The total number of pages included with this addendum sixteen (16).

The following are questions asked at the pre-bid meeting held on April 7, 2014 or submitted to the Maine Turnpike Authority in writing. Answers to the questions are noted. Bidders shall utilize this information in preparing their bid.

BRIDGE AND CULVERT REPAIRS
 4 LOCATIONS (MILE F1.7 TO MILE 84.3)

SHEET NUMBER: QT-01
 2 OF 52

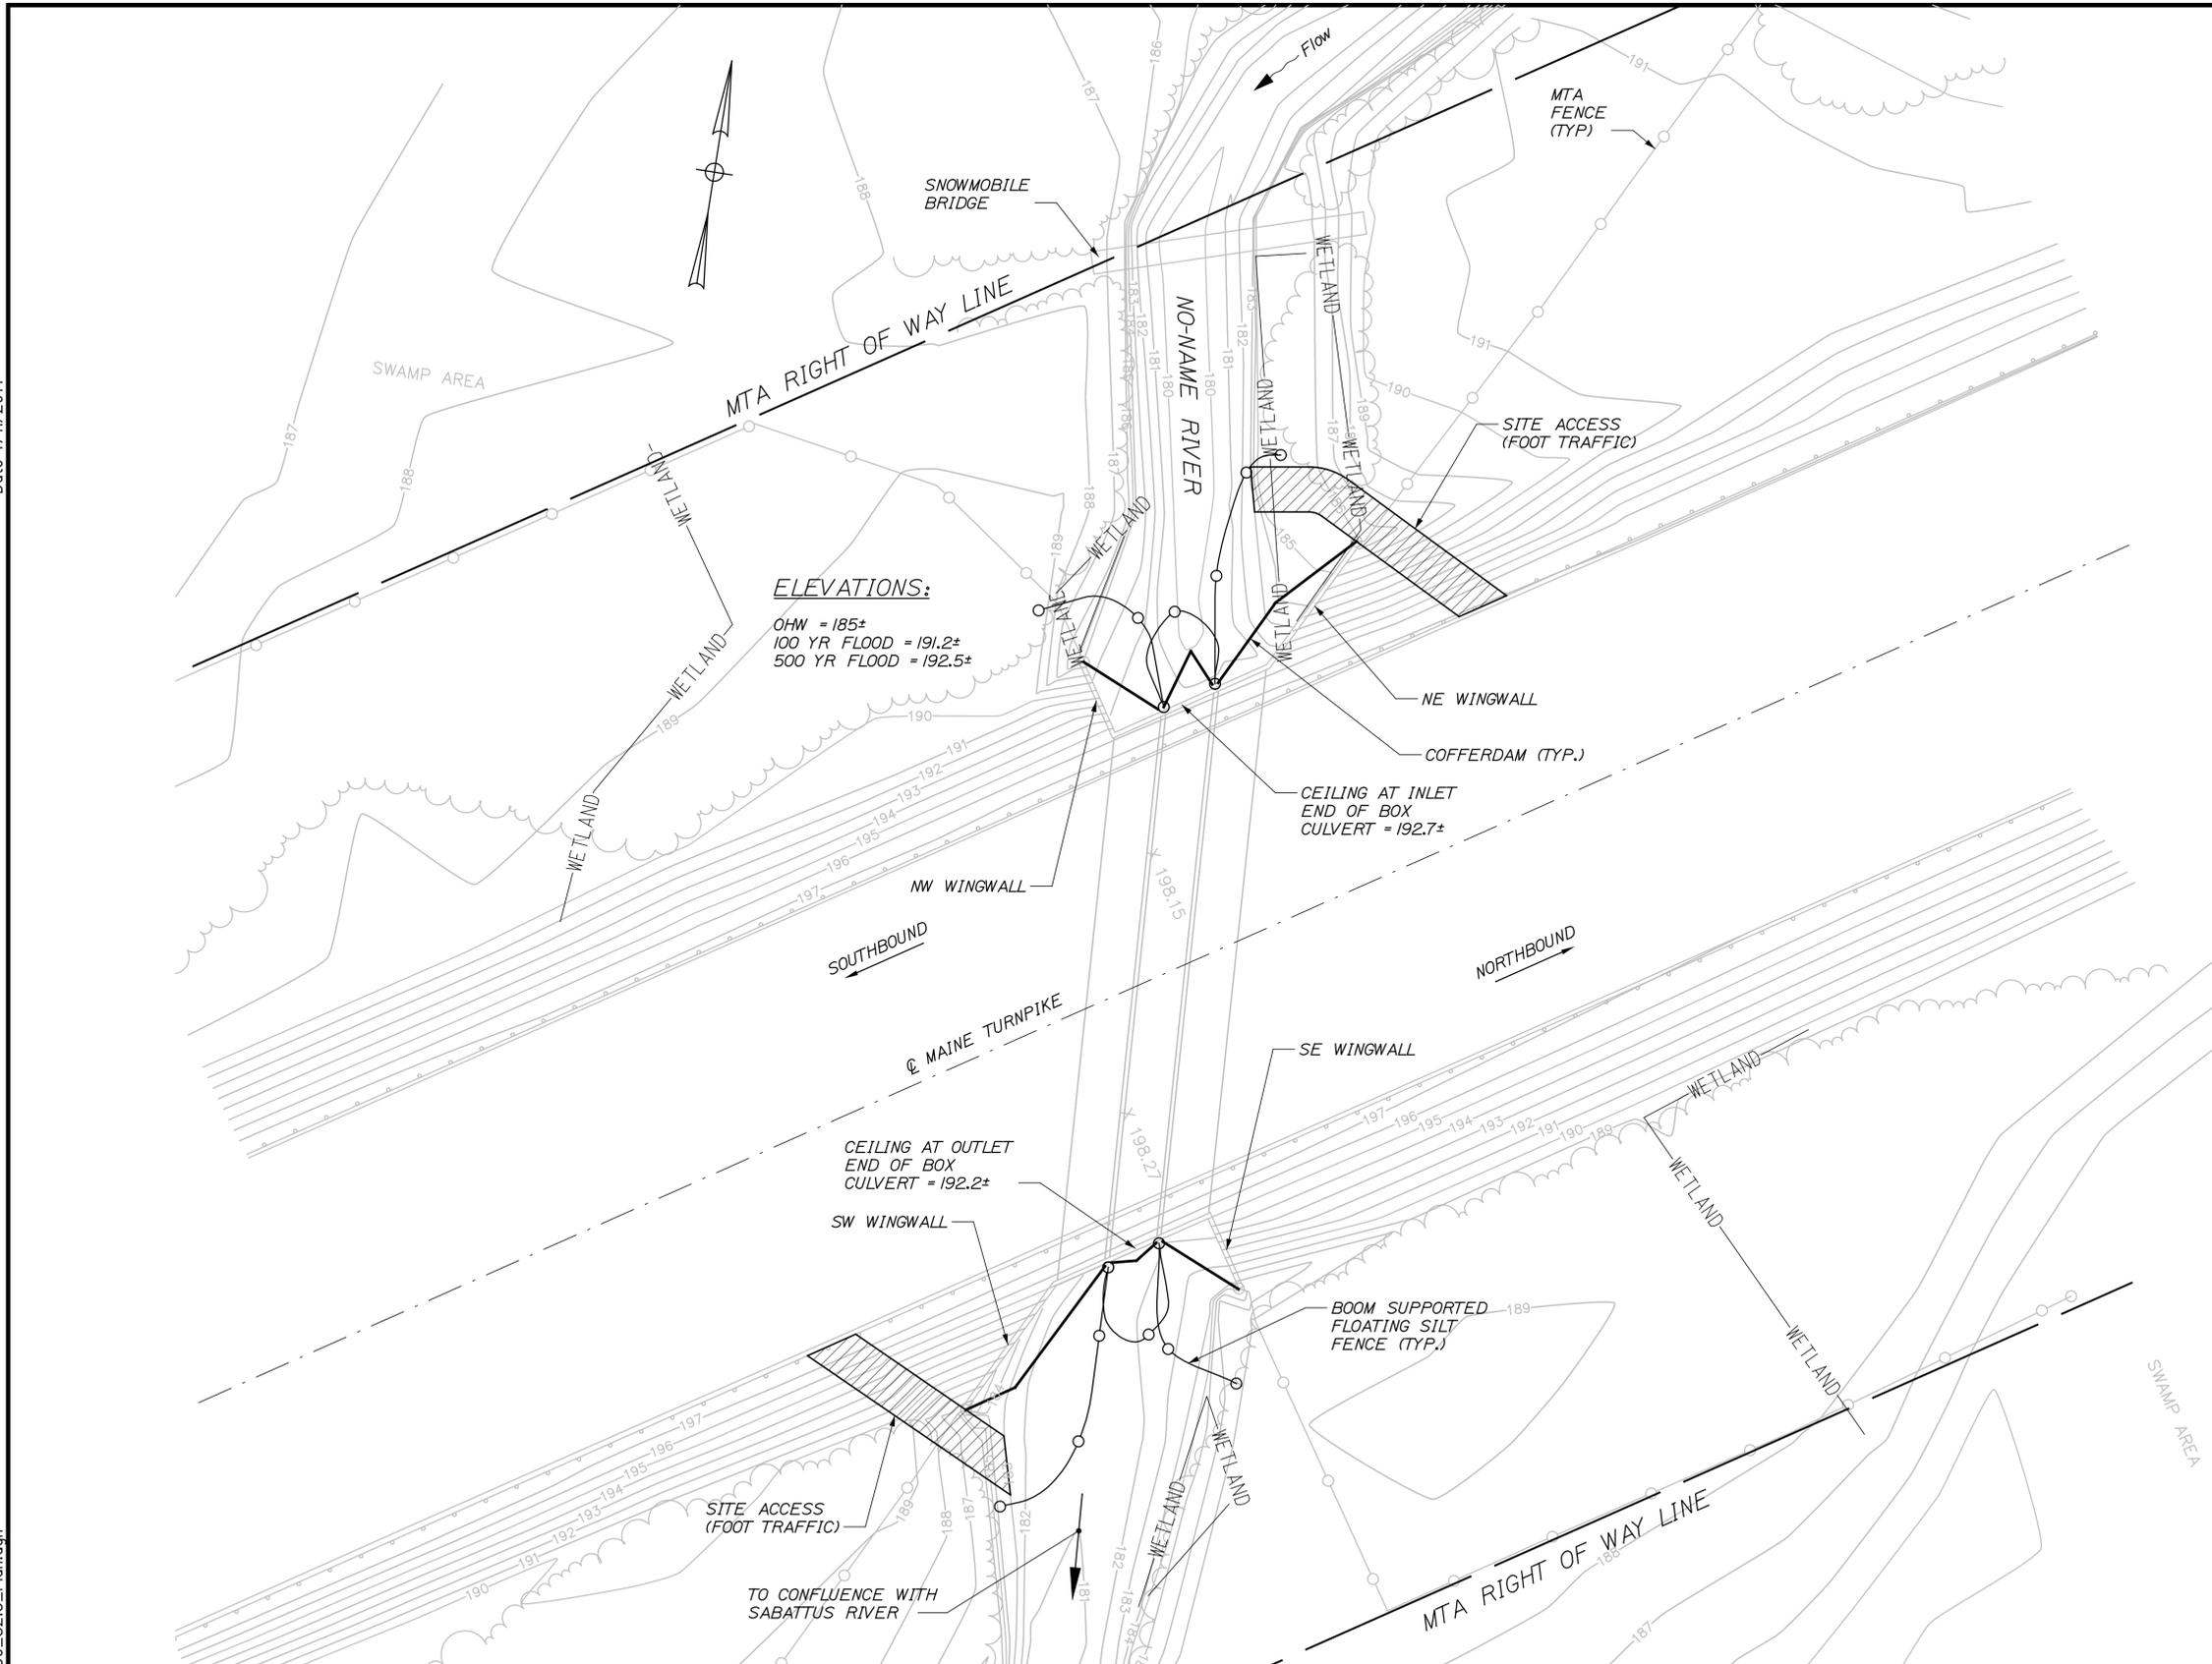
- Question 1: It is difficult to create a wetland plan without a USACE permit in hand.
Response: MTA is aware of the permit issue and will provide the permit as soon as it becomes available. The Corps is awaiting input by U.S. Fish & Wildlife.
- Question 2: Can the MTA supply temporary concrete barrier?
Response: MTA will supply 500 LF of temporary concrete barrier. Any additional temporary concrete barrier required shall be furnished by the Contractor.
- Question 3: In reference to sheet 16 of 52 note 2 and 7, will the authority consider either unit price items or payment by the labor and equipment items for the noted work activities? It is impossible for a contractor to determine quantities to develop accurate costs based on a prebid visual inspection for the work described in notes 2 and 7.
Response: Pay items have been added to cover this work.

520.2212	EXPANSION DEVICE REPAIR (CENTER ROAD)	EA		2			2
520.2213	EXPANSION DEVICE REPAIR (LISBON ROAD)	EA				2	2
526.306	TEMPORARY CONCRETE BARRIER, TYPE 1 - SUPPLIED BY THE AUTHORITY	LS	0.58	0.42			1
